ACCELERATED DISTRIBUTION DEMONSTRATION SYSTEM

Donald C. Cook Nuclear Plant Units 1 and 2
Docket Nos. 50-315 and 50-316
License Nos. DPR-58 and DPR-74
RESPONSE TO REQUEST FOR ADDITIONAL INFORMATION
FOR GENERIC LETTER 92-01, REV. 1
(TAC NOS. M83453 AND M83454)

UPPER SHELF CHARPY VALUES

FIGURE 1

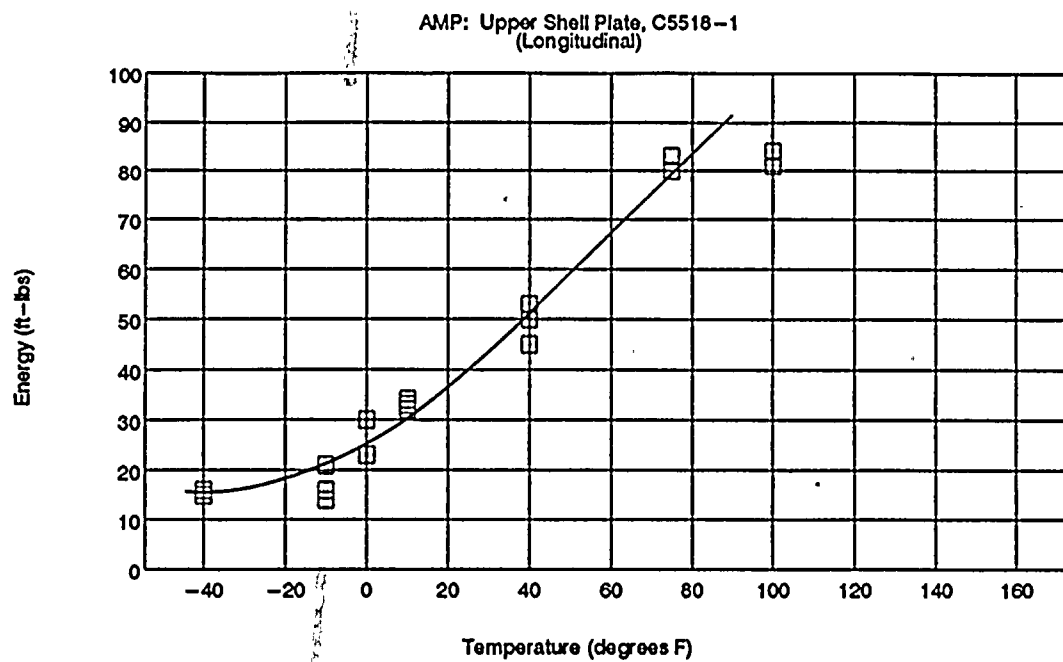
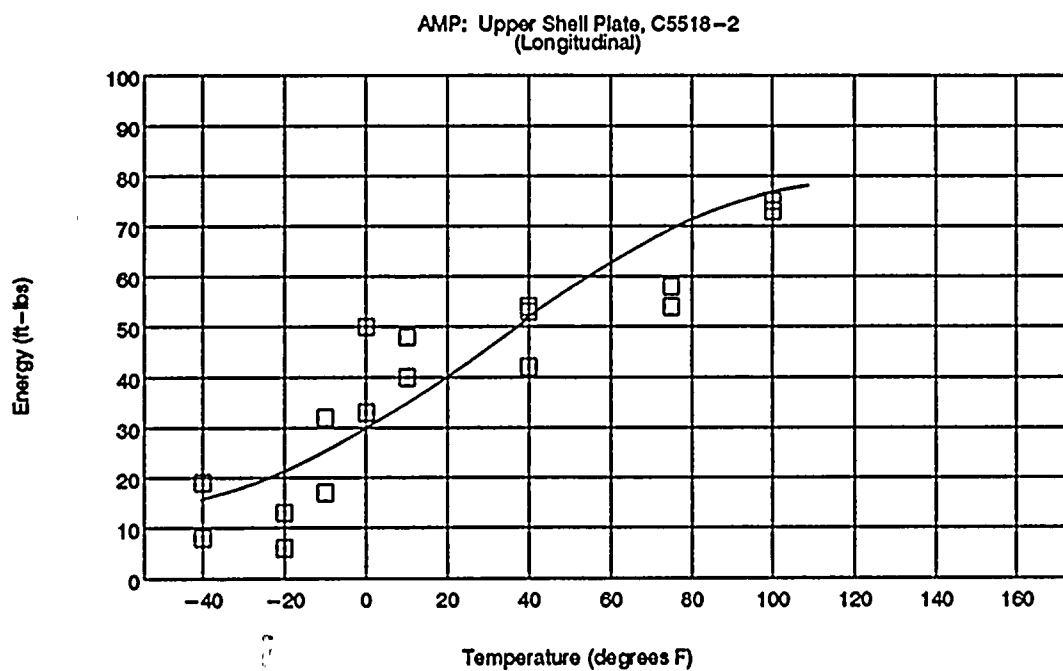
upper shelf impact energy of 56 ft-lbs, 56 ft-lbs and 57 ft-lbs, respectively. Plates C5518-1 and C5518-2 are from the same heat of steel. The designation of 1 and 2 refer to the plate number as they were cut off during the hot rolling. From the partial energy versus temperature curve given in Figures 1 and 2 for C5518-1 and C5518-2 one would expect the upper shelf energy would plateau above that shown on the abbreviated curve such that the initial transverse energy (0.65 x longitudinal) would be above 56 ft-lbs, ensuring that the 50 ft-lb EOL energy requirement is exceeded. The partial Charpy impact energy versus temperature curve for plate C5521-1 is shown in Figure 3. Similarly, one would expect the upper shelf energy of plate C5521-1 to plateau above that shown in Figure 3. This can be confirmed from the transverse Charpy impact data for intermediate shell plate C5521-2, Figure 4. Plate C5521-2 charpy V-notch impact energy versus temperature curve for specimens oriented in the transverse direction (axis of the specimen perpendicular to the major working direction) is shown in Figure 4 and shows an upper shelf energy of 86 ft-lbs. Based on the projected EOL fluence, copper content (see Table 2), Regulatory Guide 1.99, Revision 2 methodology results in a predicted decrease of 11.5% in upper shelf energy at EOL for upper shell course plate C5521-1 resulting in a EOL upper shelf energy of 76 ft-lbs (0.885 x 86 ft-lbs).

Therefore, it can be concluded that the three upper shell plates, C5518-1, C5518-2, and C5521-1 will exceed the minimum required Charpy impact energy of 50 ft-lbs in the transverse direction during the plant's operating life.
